In the Matter of)
)
IOWA ELECTRIC LIGHT AND POWER COMPANY,)
CENTRAL IOWA POWER COOPERATIVE, AND) Docket No. 50-331
CORN BELT POWER COOPERATIVE)
)
(Duane Arnold Energy Center))

ORDER FOR MODIFICATION OF LICENSE

SAFETY EVALUATION REPORT
DUANE ARNOLD ENERGY CENTER OPERATION
WITH PLUGGED BYPASS FLOW HOLES

FIGURE A-1
 MAXIMUM AVERAGE PLANAR LINEAR HEAT GENERATION RATE
 VERSUS PLANAR AVERAGE EXPOSURE

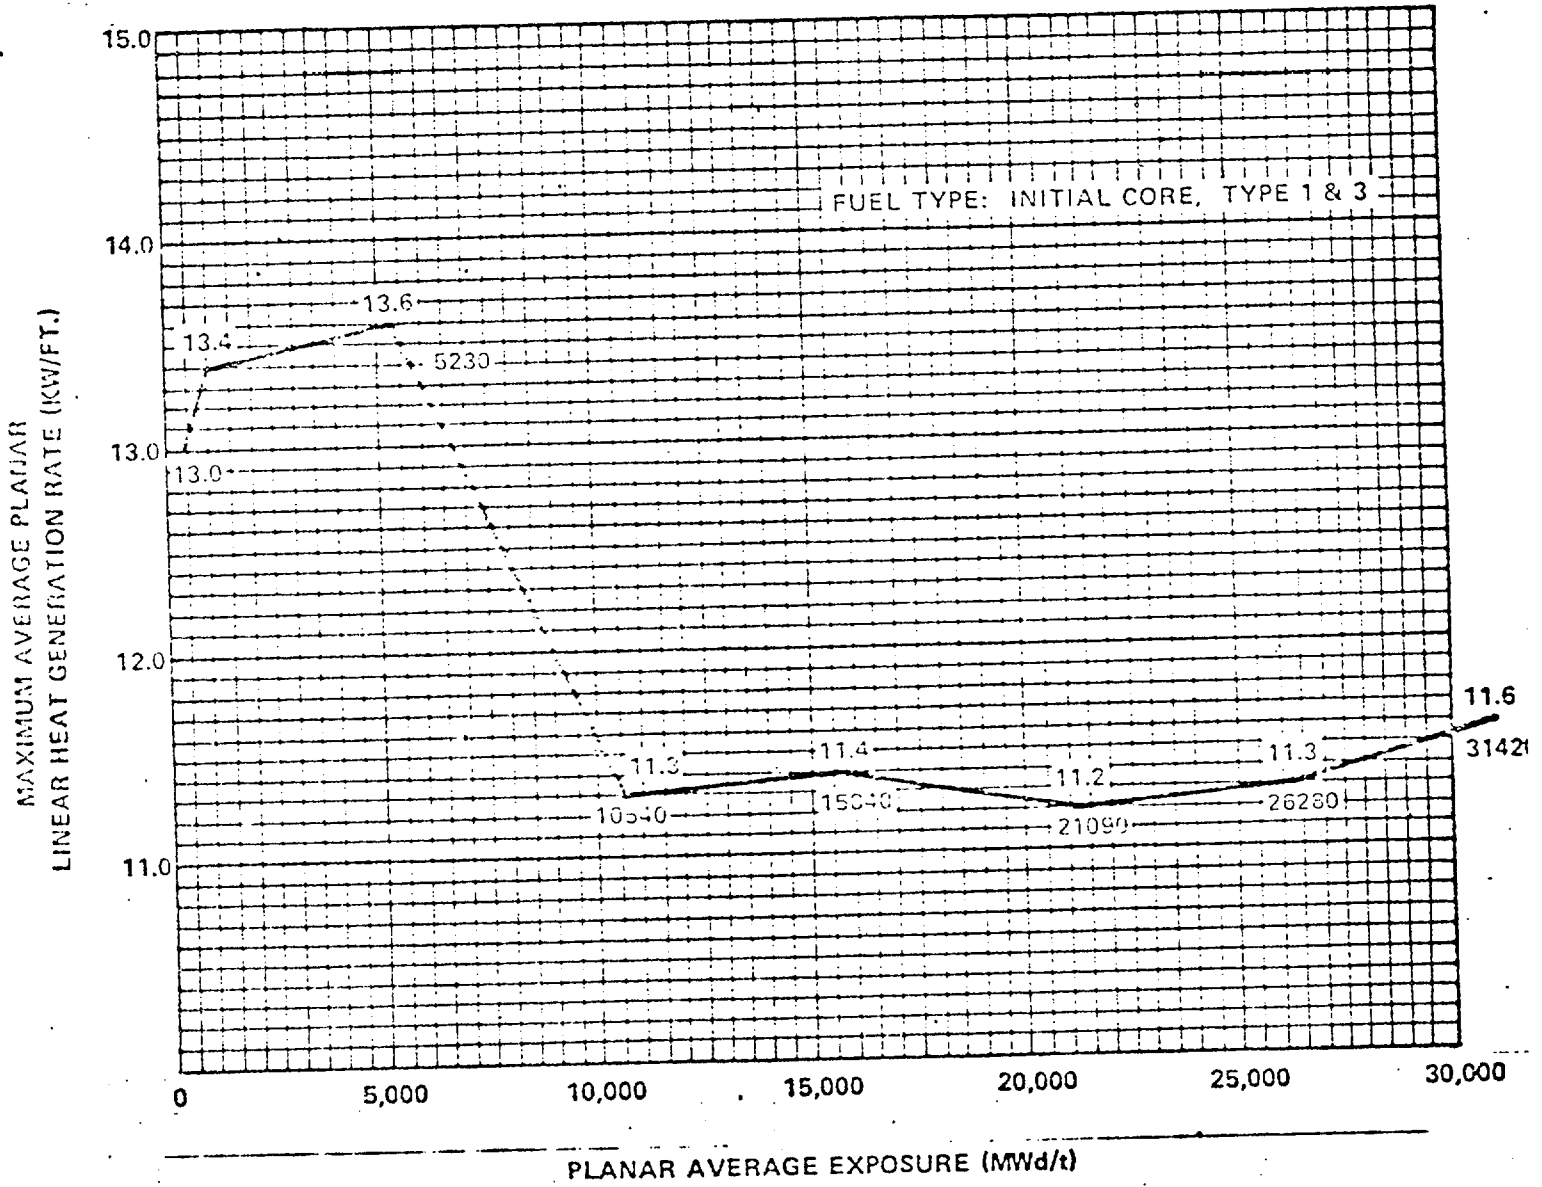
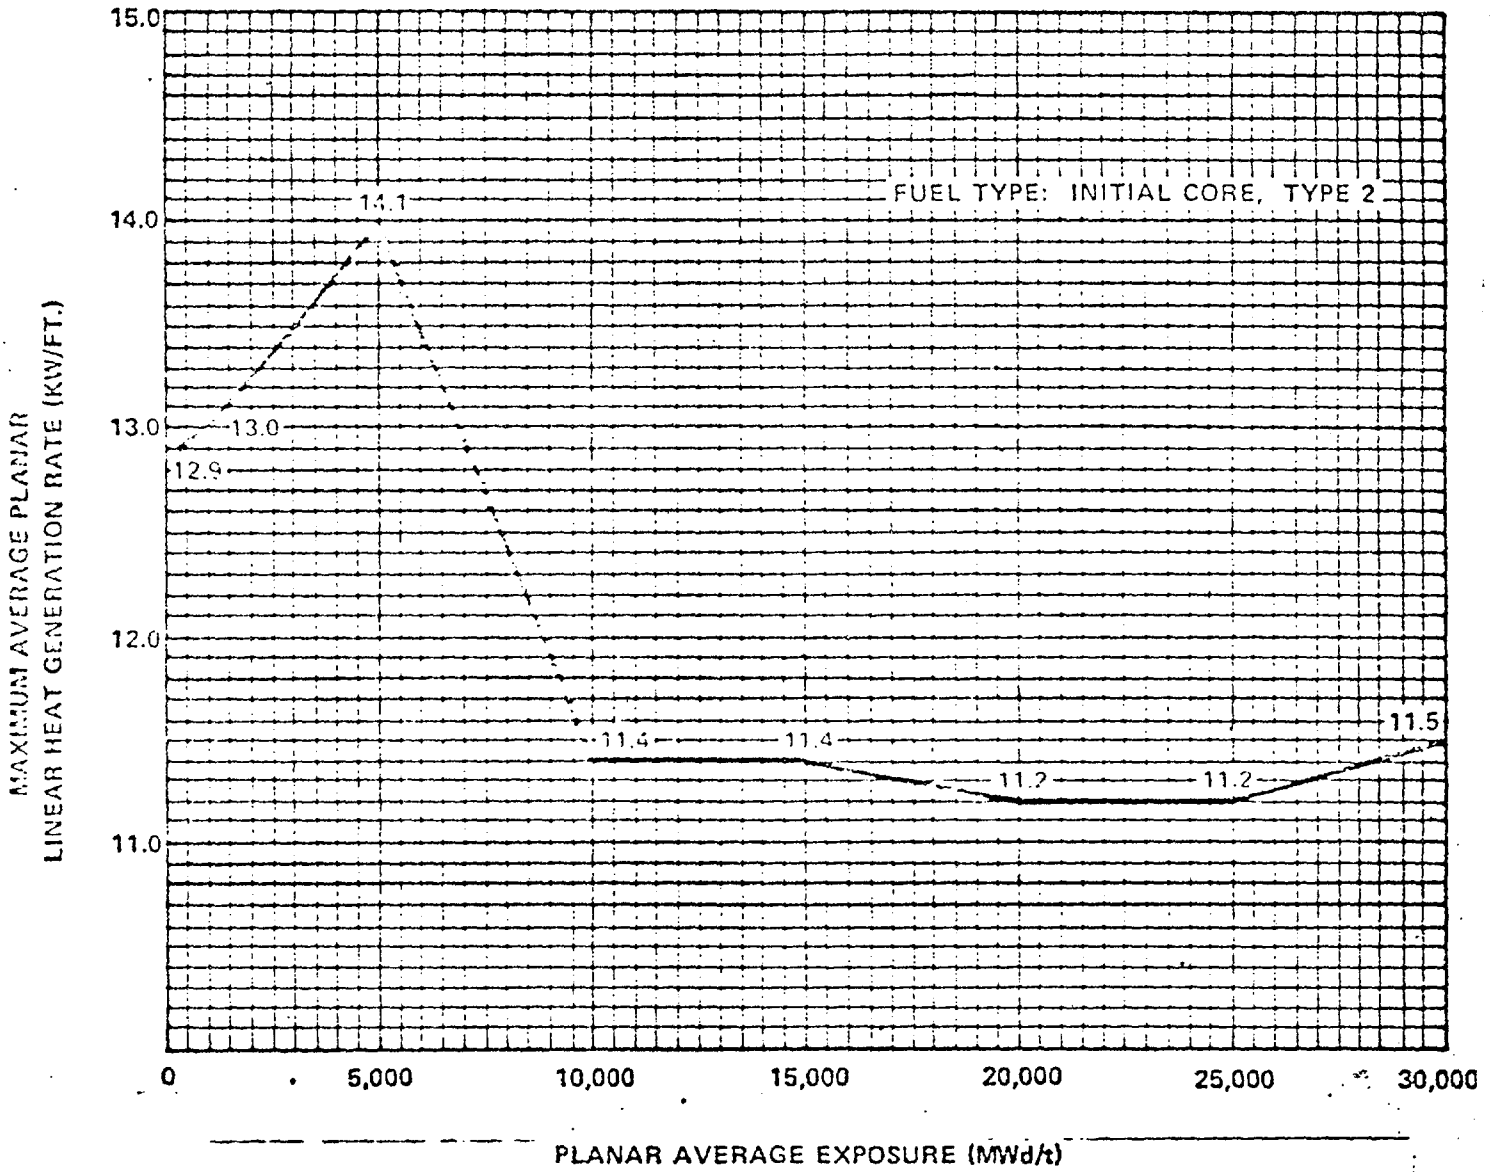
There are two limitations on the continued operation of the reactor for the remainder of Cycle 1. These are the limiting assembly maximum average planar linear heat generation rate, MAPLHGR, and the minimum critical power ratio limit related to boiling crisis, MCPR. Operation shall conform to a MCPR value of 1.34 as proposed by the licensee. The limiting value of MAPLHGR included with the proposed Technical Specifications submitted on August 9, 1974 have been revised to account for the staff requirements of December 27, 1974 and the proposed operation with plugged bypass holes. The revised values are given in Figures A-1 and A-2 for fuel types 1, 2, and 3. The limiting MAPLHGR for the four replacement fuel assemblies is 9.0 kw/ft.

FIGURE A-1
MAXIMUM AVERAGE PLANAR LINEAR HEAT GENERATION RATE
VERSUS PLANAR AVERAGE EXPOSURE

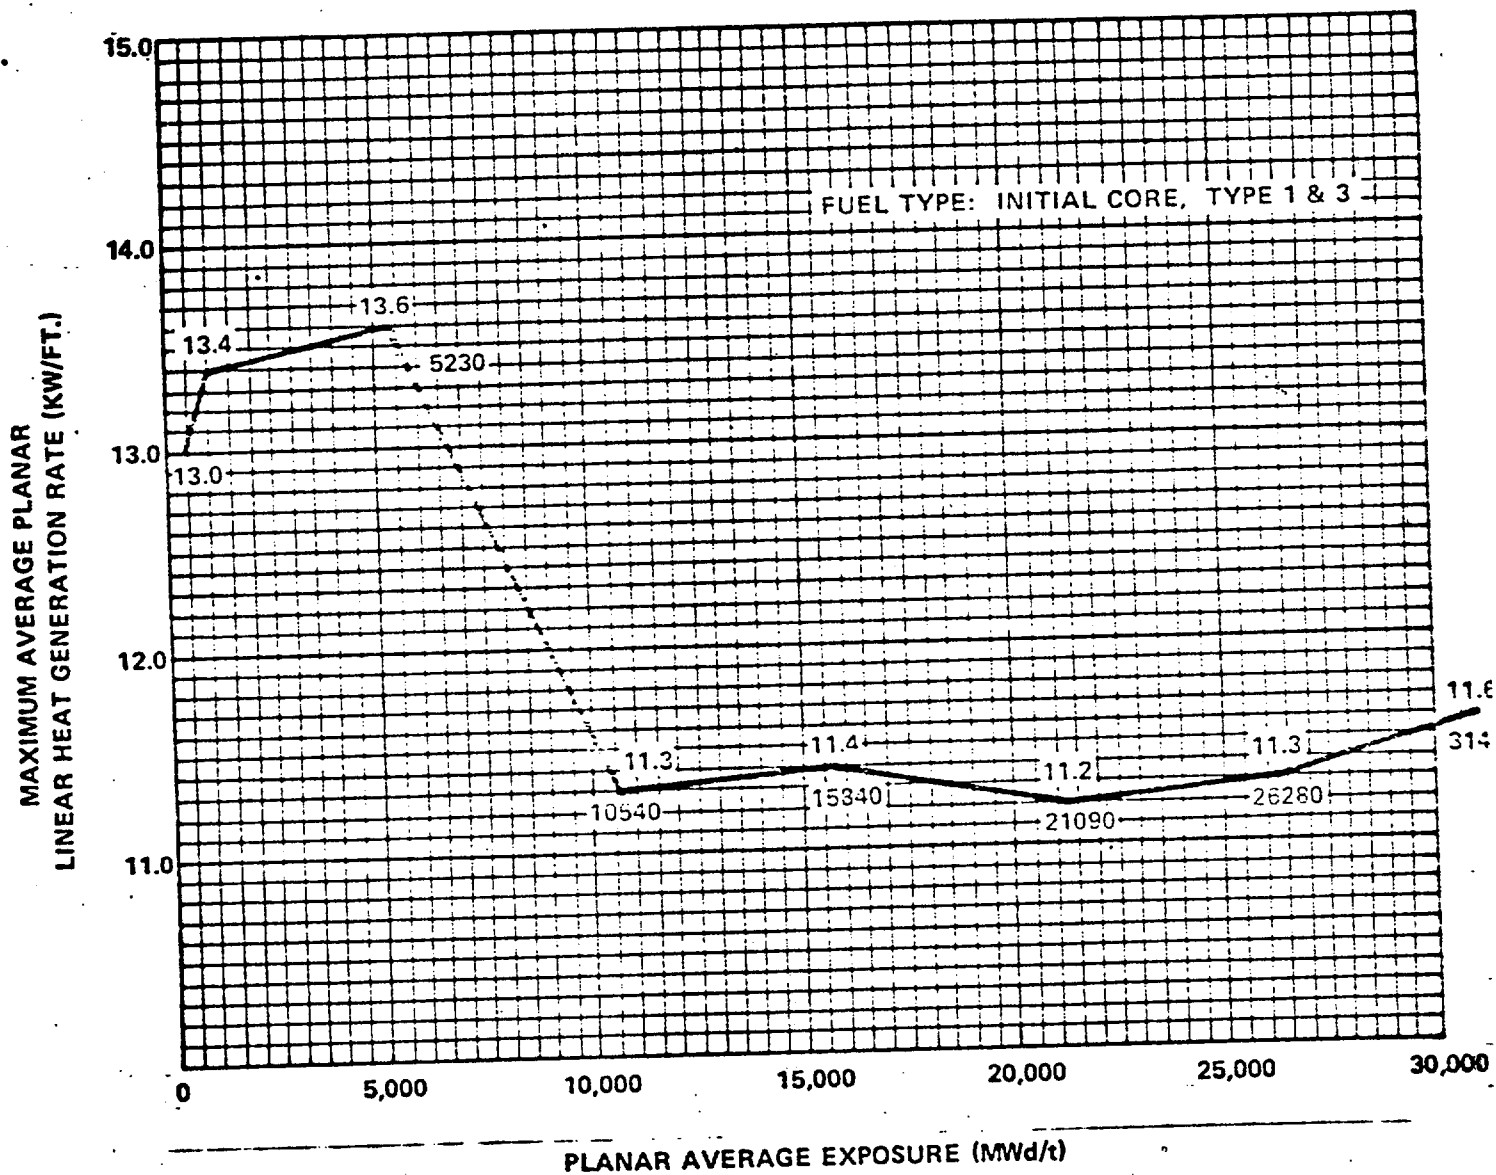
There are two limitations on the continued operation of the reactor for the remainder of Cycle 1. These are the limiting assembly maximum average planar linear heat generation rate, MAPLHGR, and the minimum critical power ratio limit related to boiling crisis, MCPR. Operation shall conform to a MCPR value of 1.34 as proposed by the licensee. The limiting value of MAPLHGR included with the proposed Technical Specifications submitted on August 9, 1974 have been revised to account for the staff requirements of December 27, 1974 and the proposed operation with plugged bypass holes. The revised values are given in Figures A-1 and A-2 for fuel types 1, 2, and 3. The limiting MAPLHGR for the four replacement fuel assemblies is 9.0 kw/ft.

FIGURE A-2
MAXIMUM AVERAGE PLANAR LINEAR HEAT GENERATION RATE
VERSUS PLANAR AVERAGE EXPOSURE

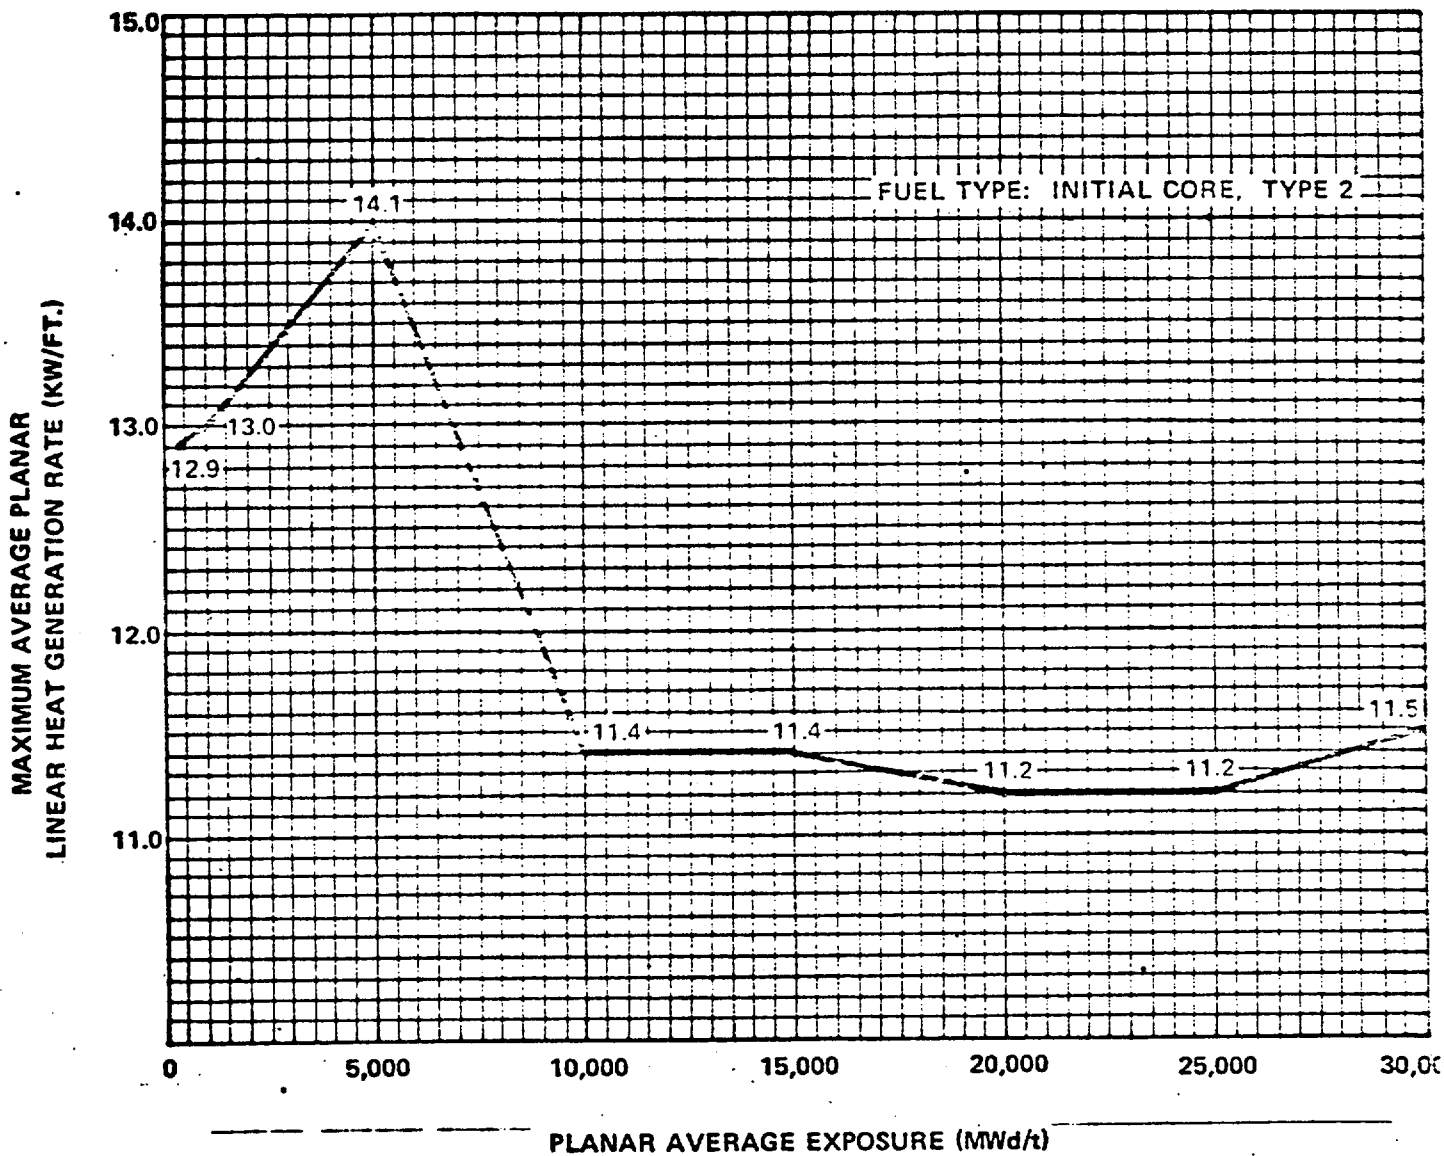
The licensee presented the results of a sensitivity study (4) that showed the calculated MAPLHGR's for the four replacement fuel assemblies are as much as 12 percent lower than similarly calculated MAPLHGR's for fuel type 2. Using the acceptable MAPLHGR's for fuel type 2 (Fig. A-2) and a 12 percent reduction factor, the staff calculated an equivalent minimum MAPLHGR of 9.9 kw/ft for the four replacement fuel assemblies at a burnup of 20,000 MWd/t. As an added conservatism, the staff reduced this value by 0.9 kw/ft to derive an acceptable MAPLHGR of 9.0 kw/ft for the four replacement assemblies. It is not expected that these assemblies will be limiting because they are located at the periphery of the core where the assembly power is low. This MAPLHGR limit (9.0 kw/ft) is acceptable for interim operation until such time as the Appendix K submittal is reviewed by the staff.
